Product Change Notification – Minor change

Purpose of notification: Addition of KC mark for selected Swissbit NAND Flash products

PCN22-0065 Page 1 of 2

Product illustration (example 1.9TB):

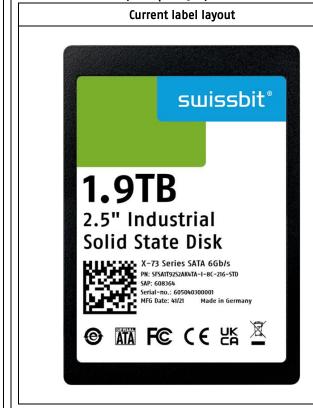
Swissbit received the Korea Certification (KC) for the X-73 2.5" SATA SSD series and will implement the additional KC marking on this series.

The material of the label does not change. In addition, the change has no impact on the functionality, reliability or compatibility of the products.
